SUBDIVISION REVIEW SHEET

CASE NO.: C8-2017-0171.0A variances only **ZAP DATE:** March 20, 2018

SUBDIVISION NAME: 7300 South Congress

SUBJECT: Variance Request 7300 S Congress

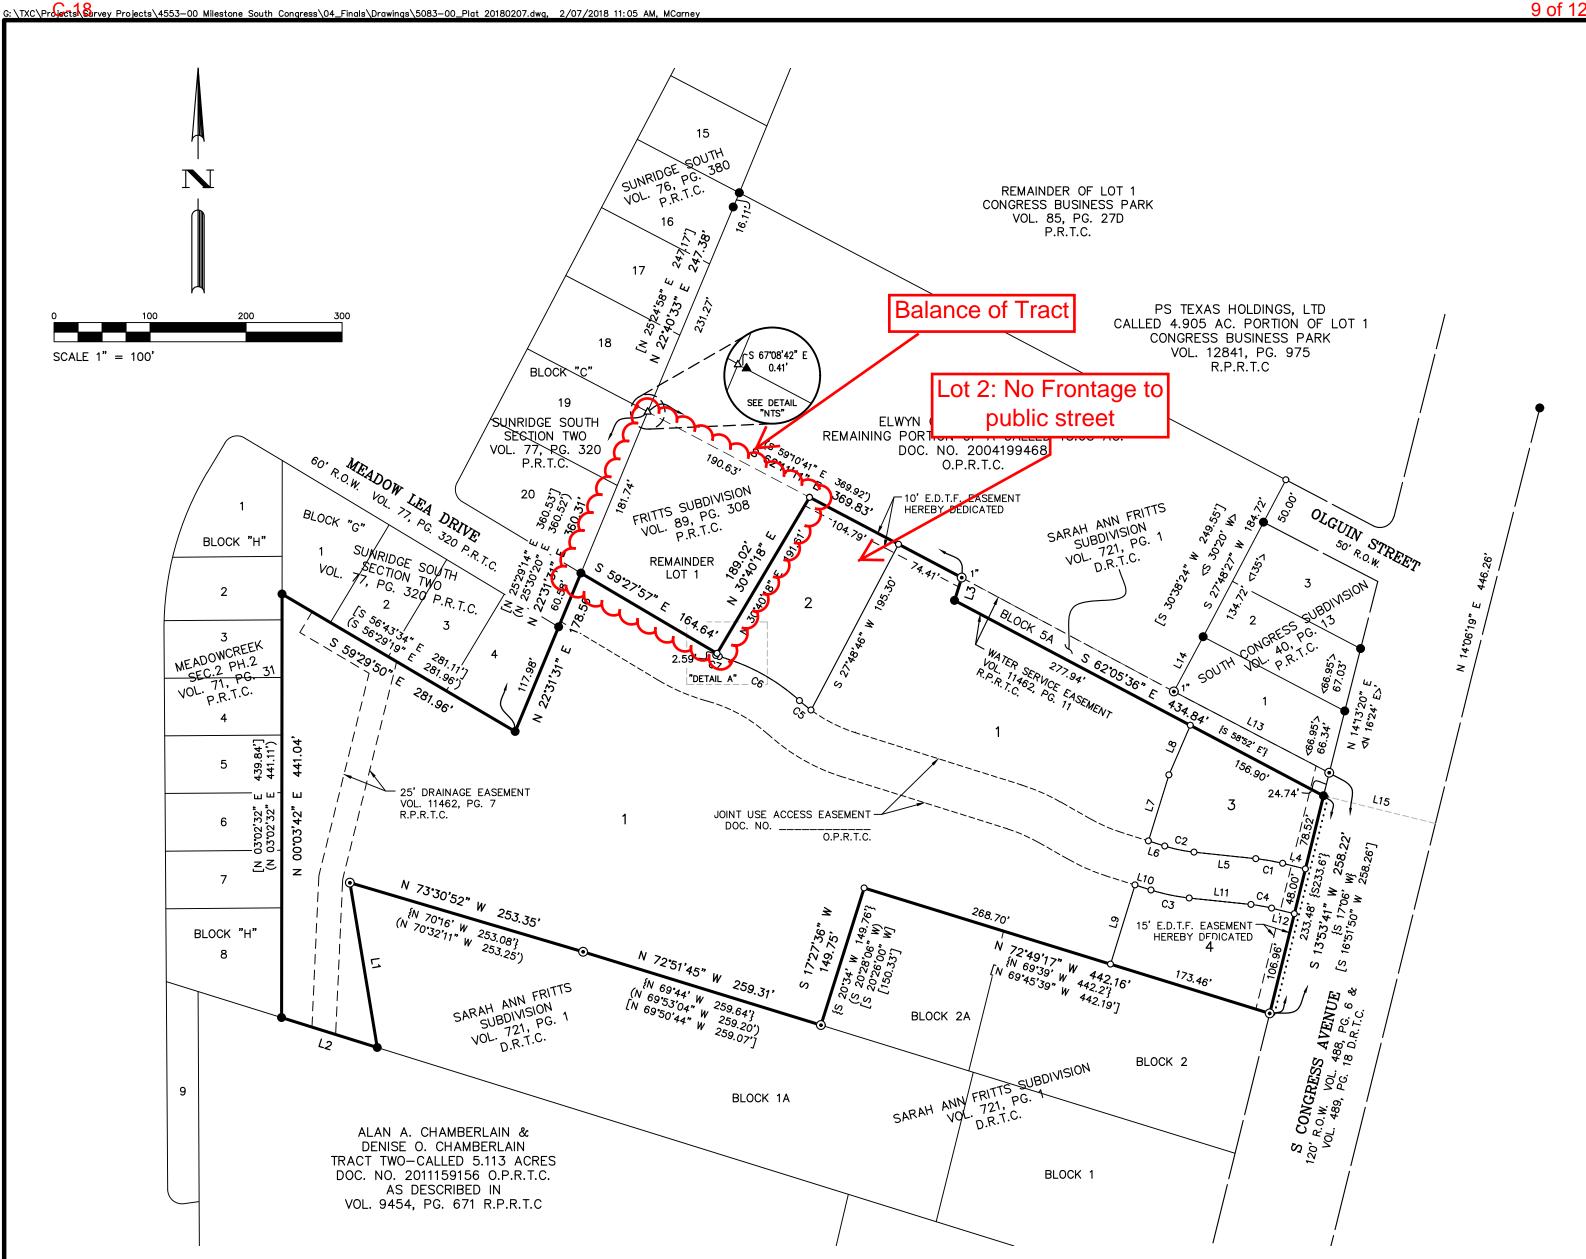
- The connecting private drive will be constructed to match Exhibit A of this packet, which includes a 49' cross section, 28' pavement width, a 5' planting zone, and 5' sidewalks on each side.

7300 SOUTH CONGRESS

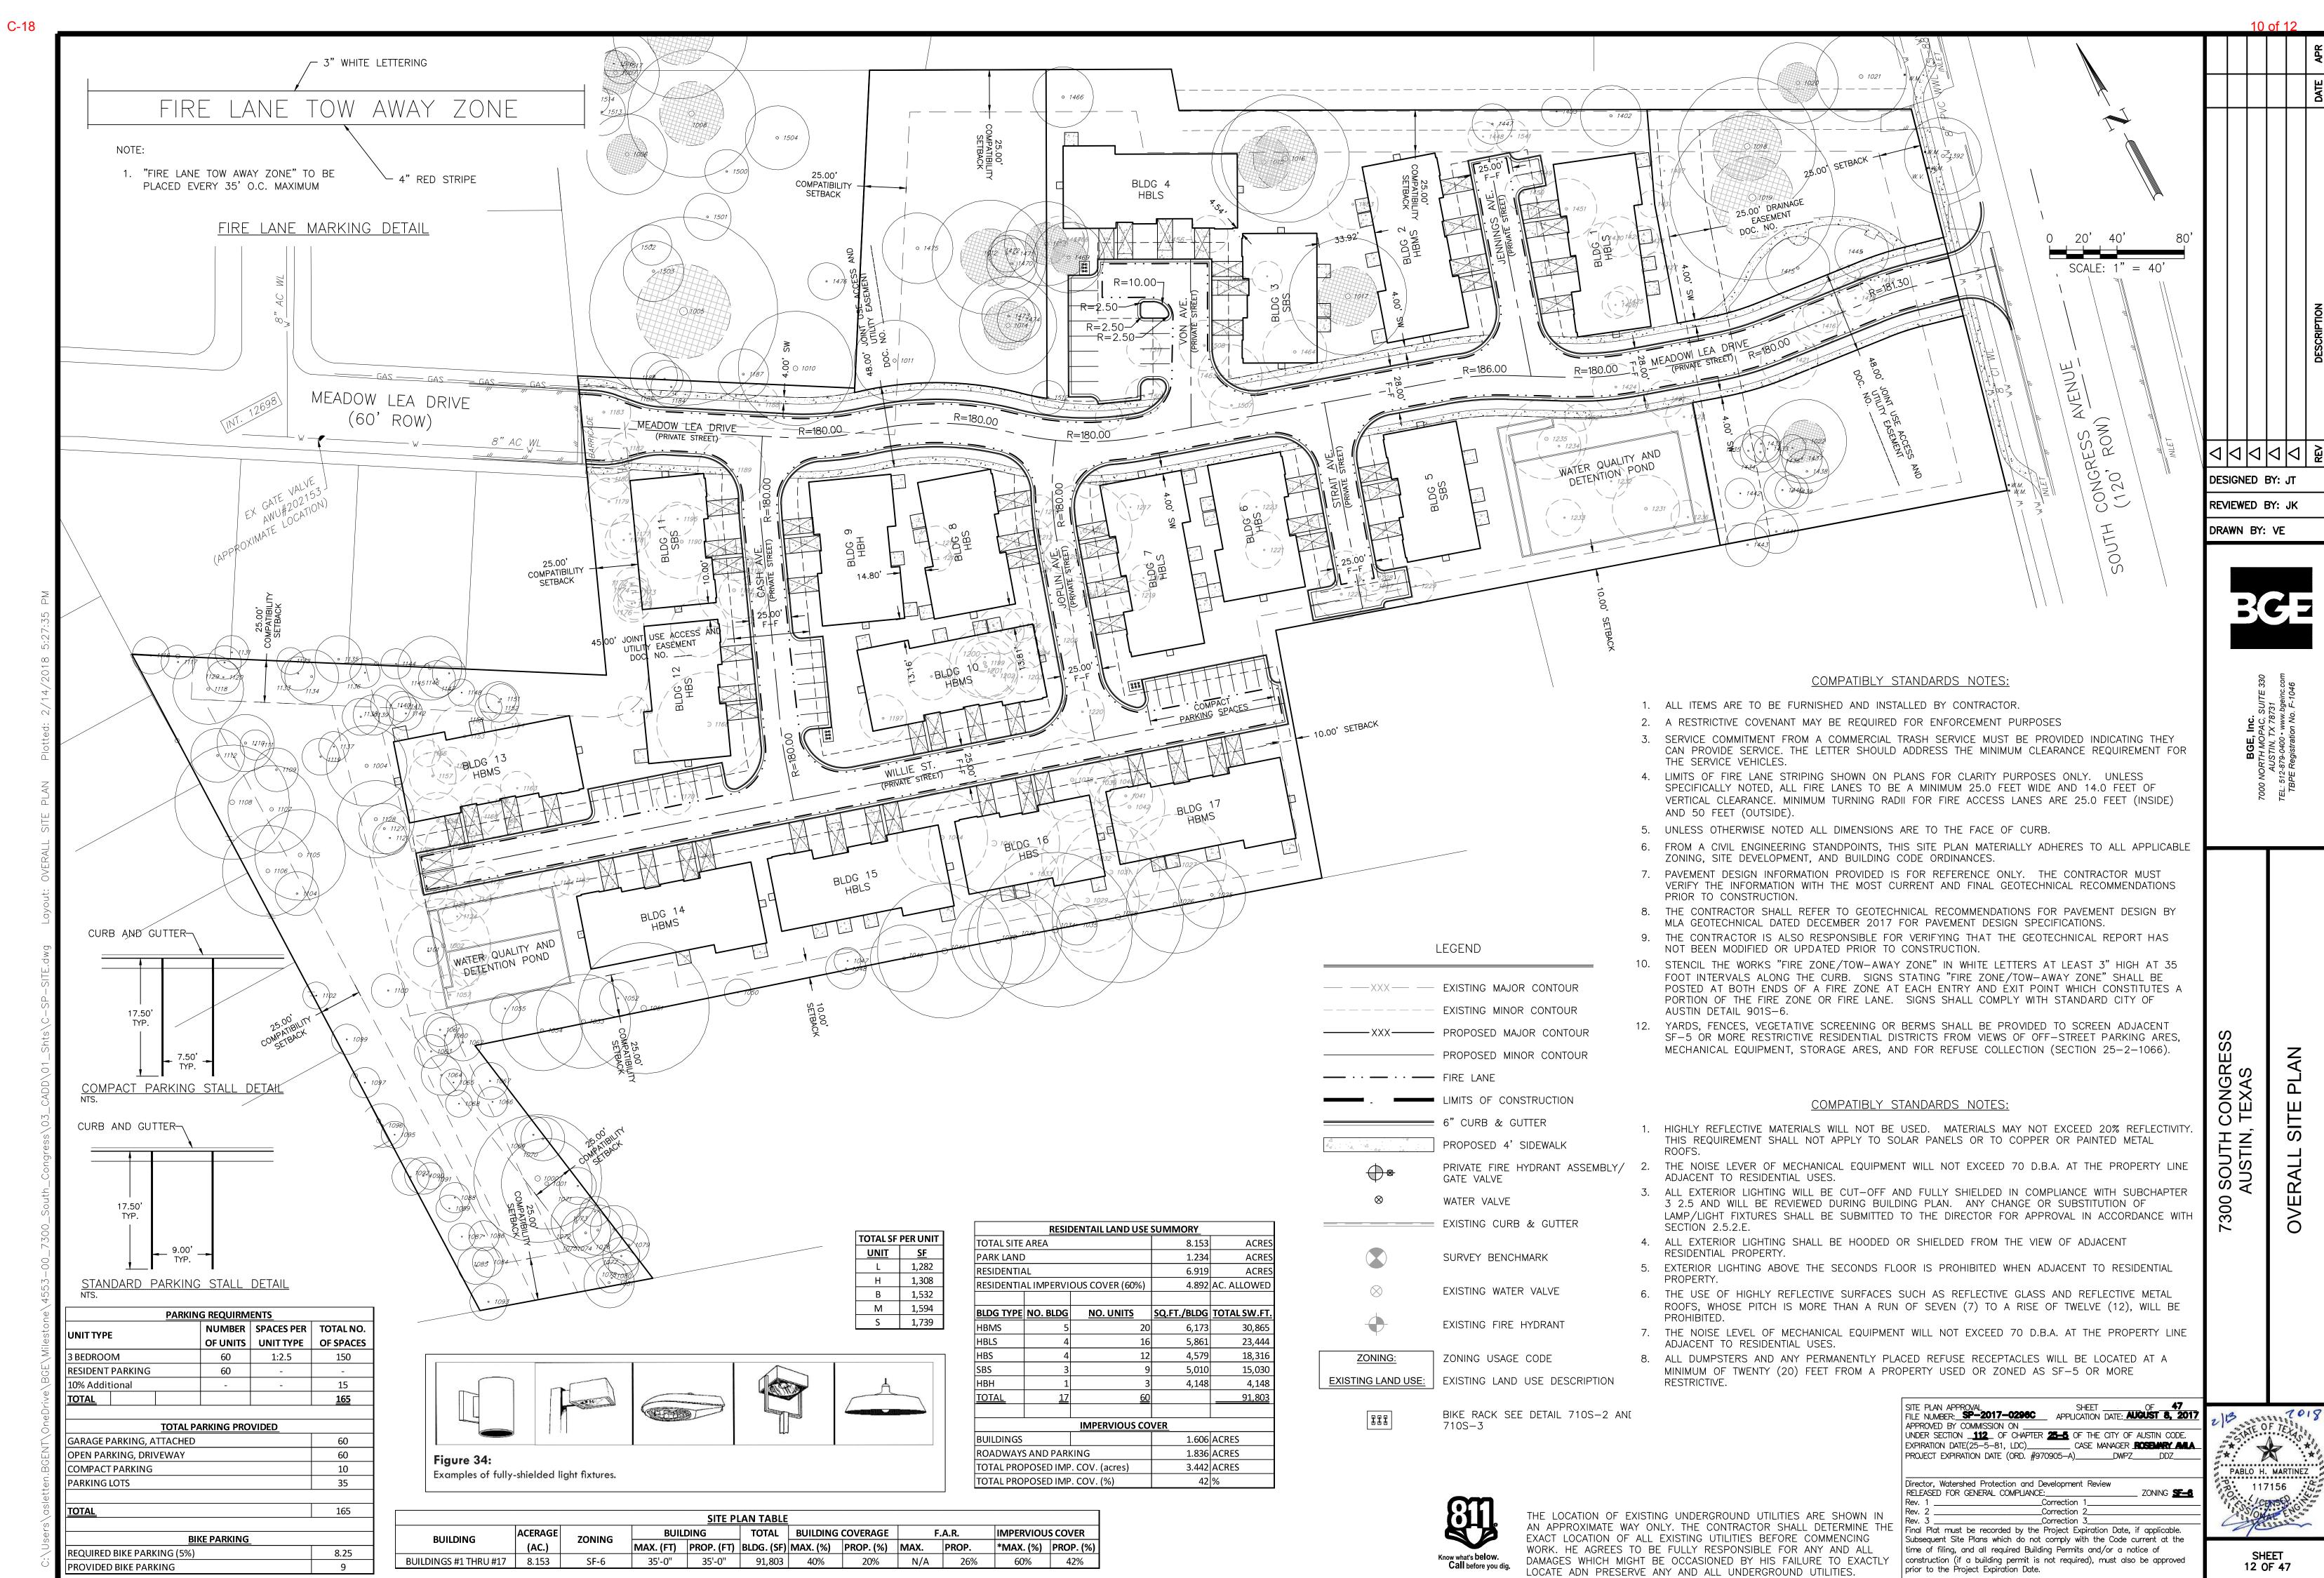
The third request is a variance from LDC 25-4-171 "Access to Lots". All lots must contain frontage to a dedicated public street. Because Lot 2 fronts the public access easement, it does not comply with this standard and a variance is required. Lot 2 contains 0.474 acre and will be dedicated as parkland. Staff recommends approval of this variance because Lot 2 is a parkland lot and the public access easement will provide adequate access.
